Rezoning Application: PD 26-0660
Zoning Hearing Master Date: July 20, 2026
BOCC Land Use Meeting Date: September 22, 2026

1.0 APPLICATION SUMMARY

Applicant: Tyler Hudson & Gardner Brewer
Hudson, P.A.
FLU Category: R-20
Service Area: Urban
Site Acreage: 11.66 AC
Community Plan Area: Northwest
Overlay: None

2.0 LAND USE MAP SET AND SUMMARY DATA**2.4 Proposed Site Plan** (partial provided below for size and orientation purposes. See Section 8.0 for full site plan)

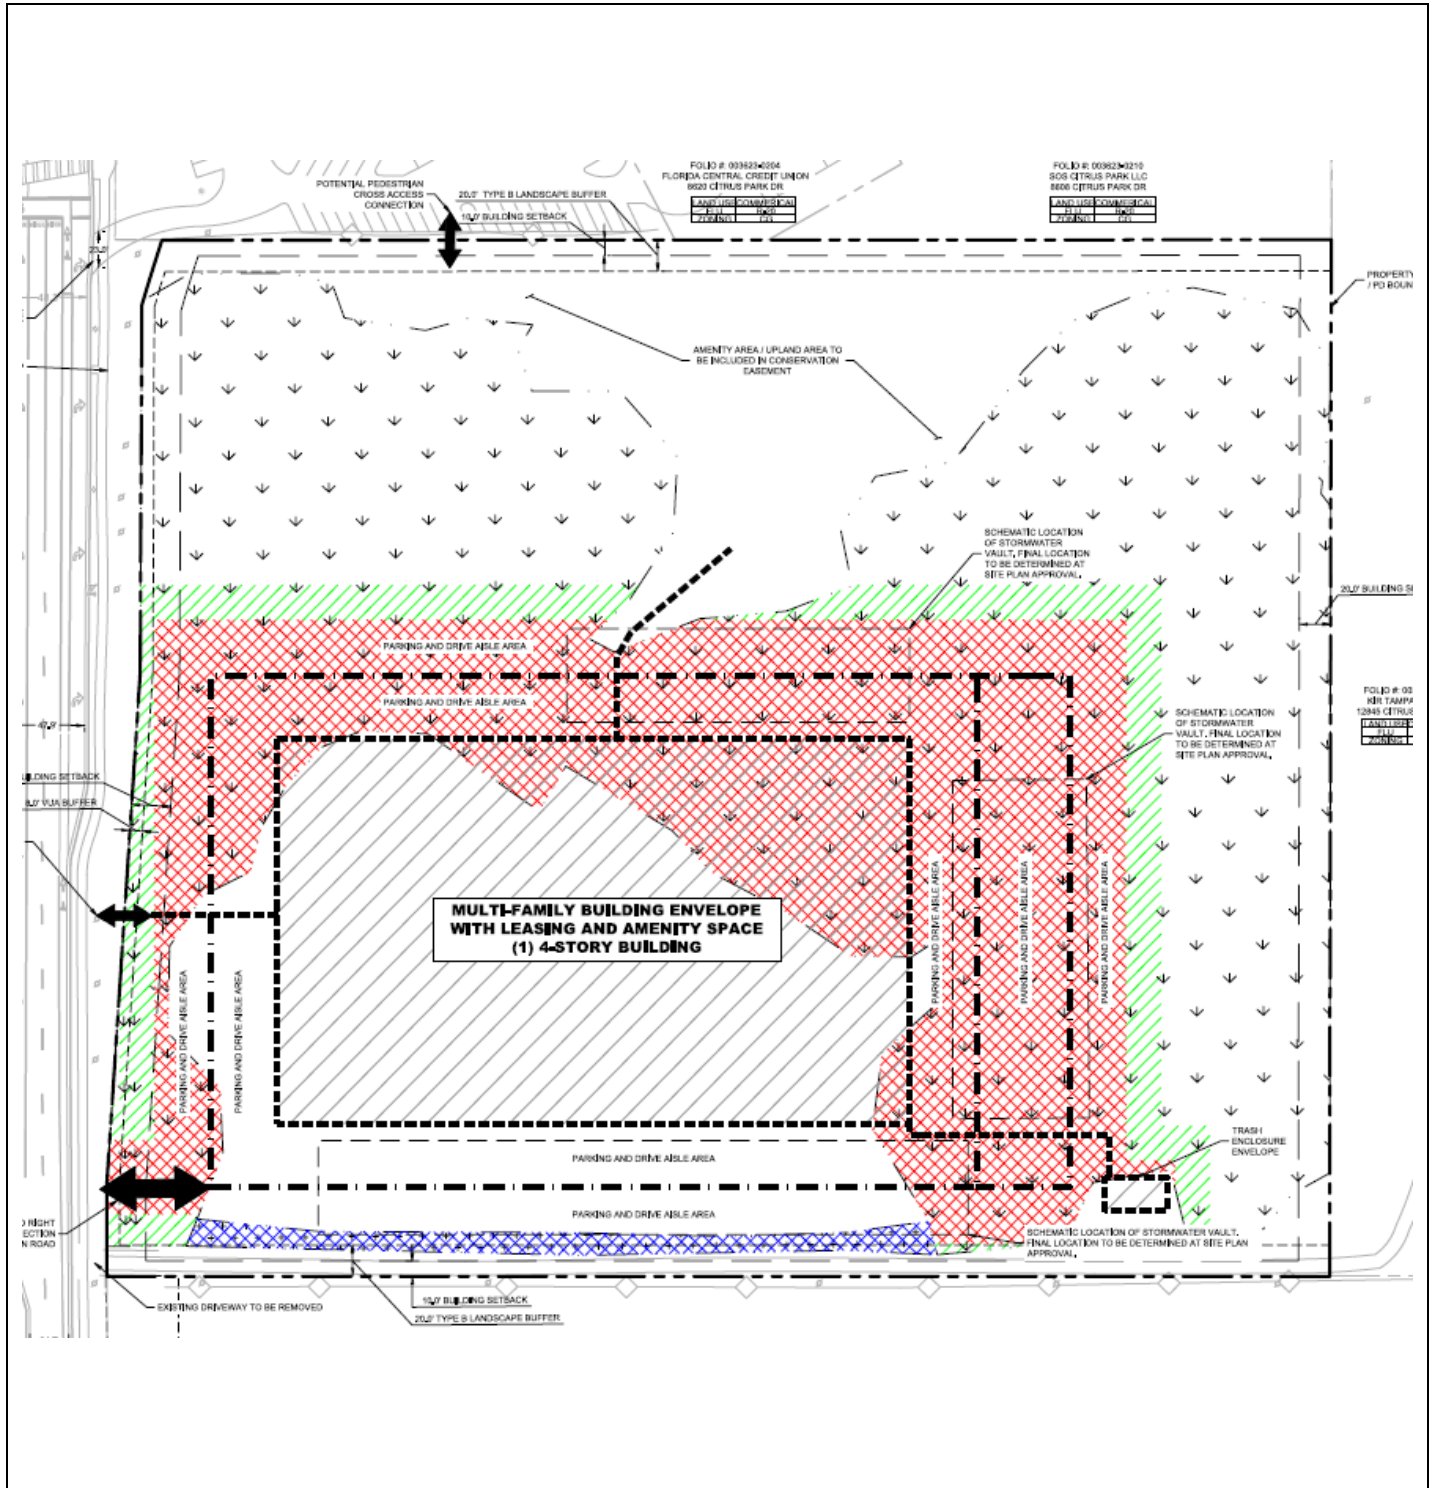
Prior to PD site plan certification, the applicant shall revise the site plan and site data table to clearly distinguish building setbacks from landscape buffers and to depict the required 20-foot Type B landscape buffer along the north PD boundary. Any site plan label, graphic, or site data table reference depicting a 10-foot north landscape buffer shall be revised to reflect the required 20-foot Type B buffer. The requested PD variation under LDC Section 6.06.06 shall apply only to the east/rear landscape buffer reduction.
